SERVICE PARTS LIST

SPECIFY CATALOG NO. AND SERIAL NO. WHEN ORDERING PARTS		REVISED BULLETIN	DATE
9" GRINDER			Aug. 2007
CATALOG NO.	6086-20	SERIAL NUMBER	991A
		WIRING INSTRUCTION 58-01-1370

RECALL NOTICE!
 See back page for important safety information.

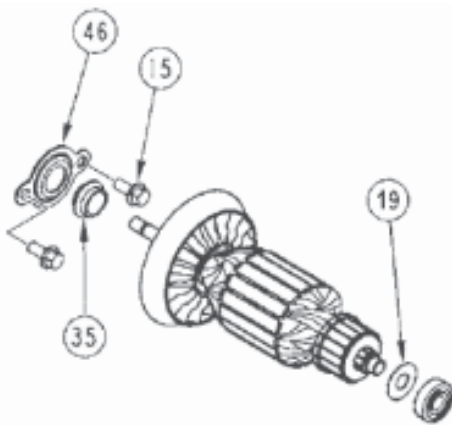
Milwaukee is providing a **no-charge** warranty service to all owners of **6086-20, 6088-20 and 6089-20 7"/9" Grinders**. We are taking this action because under certain circumstances the **'lock-on' Trigger Switch** can stick in the 'ON' position, which poses a risk of injury or property damage.

The original equipment switch (23-66-2710 / 23-66-2720) should be replaced with a new re-worked 23-66-2720. Reworked switches will have a white dot (indelible paint) applied to the location at the base of the switch (see illustration).

For operator safety a **6086-20, 6088-20 or 6089-20 7"/9" Grinder** within the listed serial number ranges should be returned to the nearest **factory** Service/Sales Support Branch or Milwaukee Authorized Service Station for a no-charge warranty replacement of the trigger switch.

If the nameplate has an **'X'** stamped into the tool's nameplate, next to the serial number, the tool has been repaired and the defective switch has already been replaced.

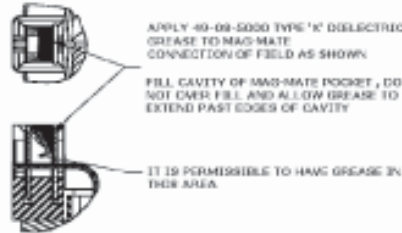
31-50-1752 Motor Housing Kit incorporates changes to the shielding of the armature pinion and commutator ball bearings along with the retaining of the pinion ball bearing into the gearcase assembly of 7"/ 9" 15Amp Sander / Grinders - 6080-20, 6081-20, 6082-20, 6086-20, 6088-20 and 6089-20.

Additionally, a change has been made to the motor housing and wiring of the tool. The ATF field coil is now 'hard-wired' with four [4] new leadwire assemblies, see **Wiring Instruction 58-01-1371**. Add 'X' Grease, 49-08-5000 to mag-mate field terminals as need.

Motor Housing Kit consist of:	Discarded Parts:	Model Affected
2ea 06-75-0510 ¼-20 Hex Screw* item 15		All
1ea 45-06-0830 Bearing Seal item 19		All
1ea 31-50-1785 Motor Housing item 26	31-50-1751 Motor Housing	All
1ea 31-53-0160 Plug**	31-53-0160 Plug*	All
1ea 31-55-0290 Dust Shield item 35		All
1ea 44-86-0040 Bearing Retainer ^A item 46	44-66-2100 Bearing Ret Plate	All
1ea 23-94-9300 LeadWire Assembly	23-94-2650 LeadWire Assy	All
1ea 23-94-9305 LeadWire Assembly	23-94-2655 LeadWire Assy	All
1ea 23-94-9310 LeadWire Assembly		All
1ea 23-94-9315 LeadWire Assembly		All
	42-96-0145 Bearing Cup	All

** running change, part modified without part number change - two wire traps added - part must have a total of 4 wire traps

^A Service Note - 'check for slip fit' - mounting of 02-04-1680 Ball Bearing to the armature shaft may require removal of a 0.0001" - 0.0002" from the O.D. of the armature pinion end ball bearing journal - it is recommended to use emery cloth and armature lathe to lightly sand, for a few seconds, removing the material necessary for the pinion shaft to be a 'slip fit through the pinion ball bearing' as it is being held in place in the GearCase by the 44-86-0040 Bearing Retainer.

* Torque 06-75-0510 to 65-75 in-lbs.
